October 15, 2008

Red Point Development  
8710 North Thornydale Road  
Tucson, Arizona 85742

**RE: Supplemental Recommendations to Geotechnical Engineering Report  
Phase I Residential Development at the Pines  
At the Pines Golf Course  
North of Cortaro Road and West of Interstate 10  
Marana, Arizona  
Terracon Project No. 63045225, Addendum 10, Revision 1**

FIG. No.  
**3**

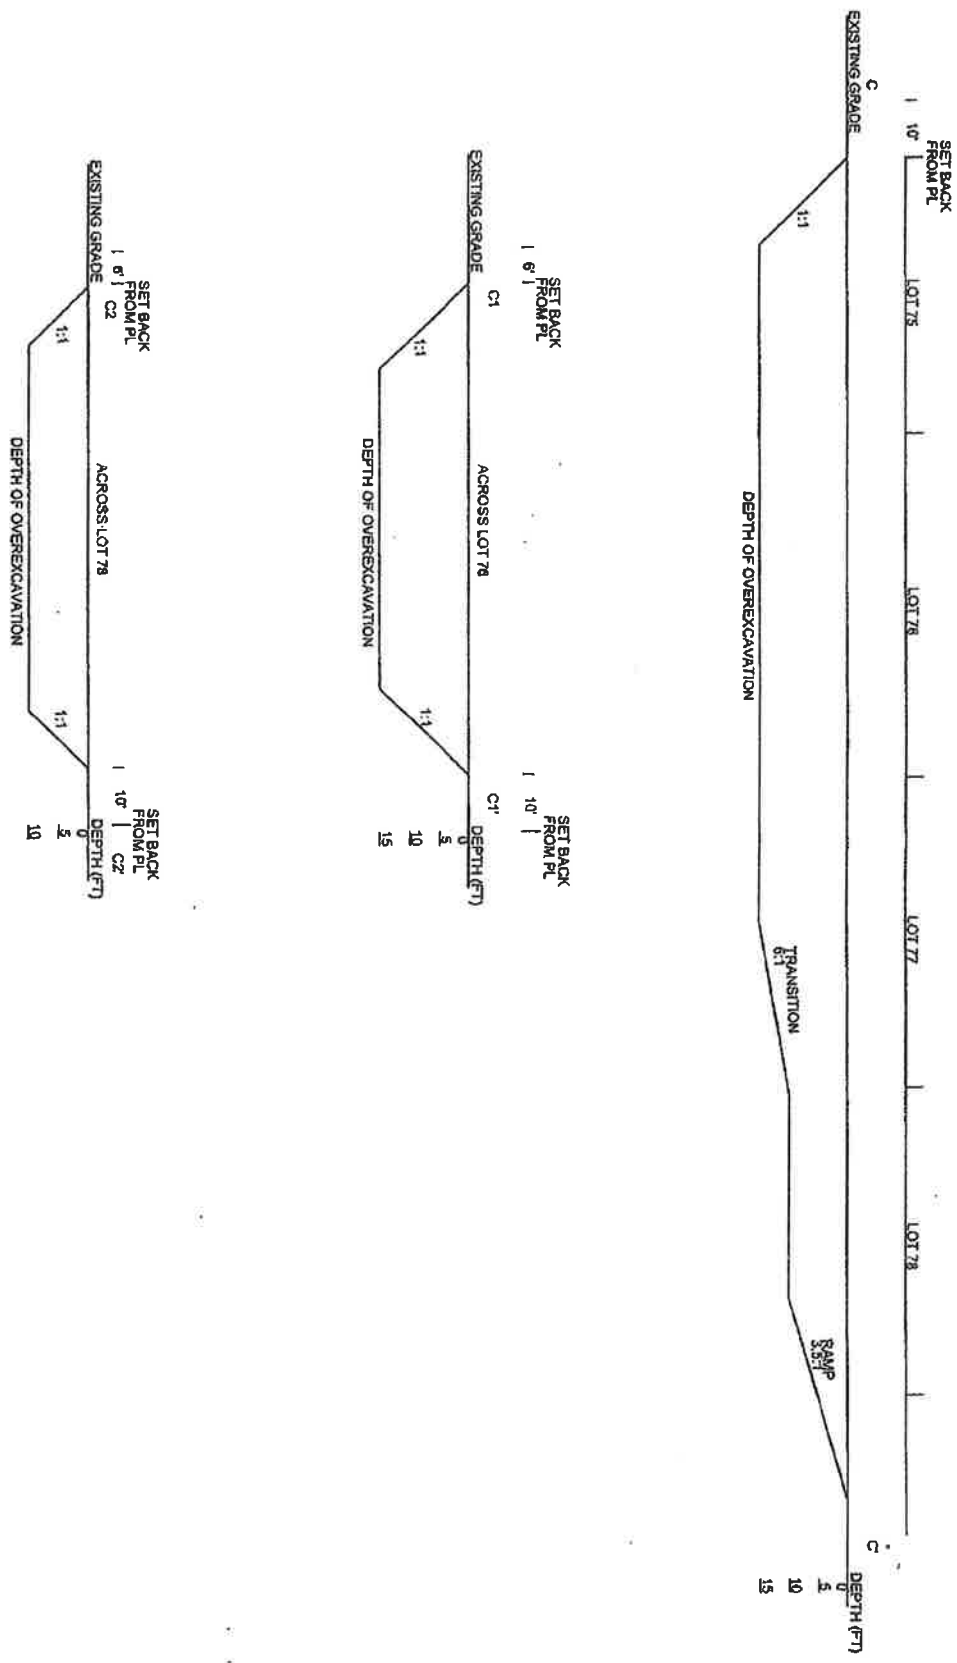
The attached Figures 1 through 6 show these areas and cross sections of our recommended overexcavation zones. Soils overexcavated and recompacted as engineered fill should be placed in loose lifts not exceeding 12-inches in height, and should be compacted to a minimum of 95 percent of Standard Proctor Density (ASTM D698) near optimum moisture content.

The cross sections indicate access ramps down into each of the excavations with inclinations of about 3.5:1 (horizontal:vertical). These slopes would not need to extend across the entire side of a given excavation, but rather be wide enough to accommodate the excavation equipment. The remainder of that side of the excavation may have slopes as steep as 1:1 (horizontal:vertical). Also, we understand some of the ramps as shown on our cross section may need to be relocated to other portions of the excavations due to existing site walls.
